Service Action: S63 Engine – Check and Replace High-Pressure Injectors

E70 (X5M)

E71 (X6M)

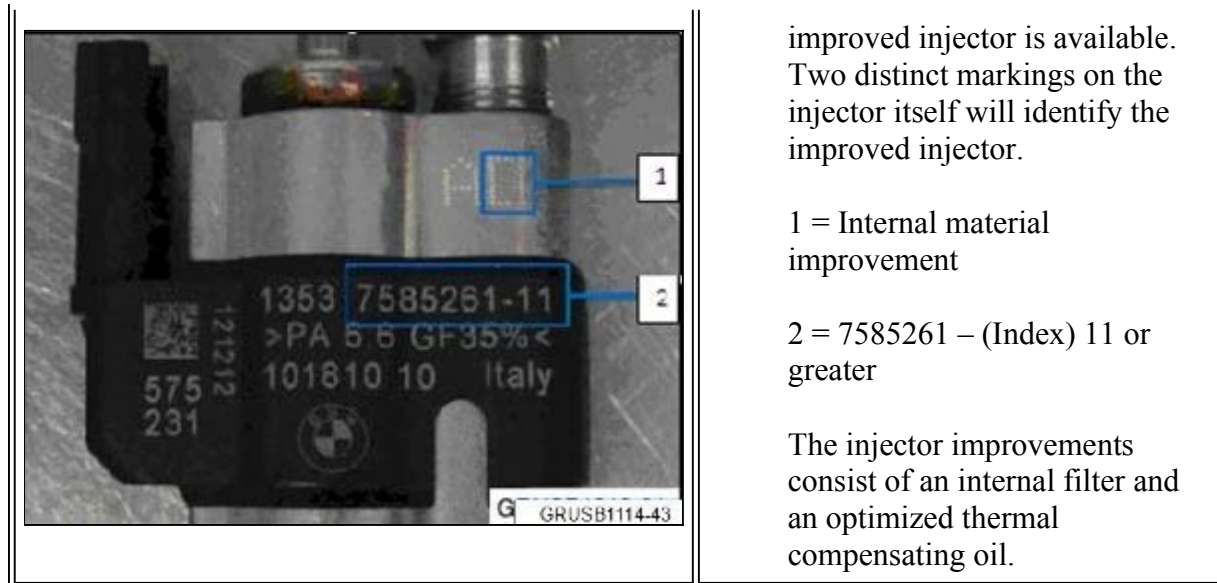
<ol style="list-style-type: none"> 1. Use a bore scope (1) or similar (mirror) to help identify the injector index number on the injector (2). <p>Do not remove the injector to identify the index number.</p>
	<ol style="list-style-type: none"> 2. Perform the injector index number evaluation on both cylinder banks. <p>As of January 2013, an</p>

improved injector is available. Two distinct markings on the injector itself will identify the improved injector.

1 = Internal material improvement

2 = 7585261 – (Index) 11 or greater

The injector improvements consist of an internal filter and an optimized thermal compensating oil.

- All injectors that are not index 11 or higher will need to be replaced. Use **P/N 13 53 8 648 937** when replacing the injector(s).

If the injector index number is already 11 or greater, take no further action regarding injector repairs.

IMPORTANT: Injectors with index 11 and higher have a different calibration and construction than injectors with index 10 and lower. Due to this difference, injectors with index 11 and higher and injectors with index 10 and lower cannot be mixed on the same engine bank (i.e., cylinders 1-4 or 5-8).
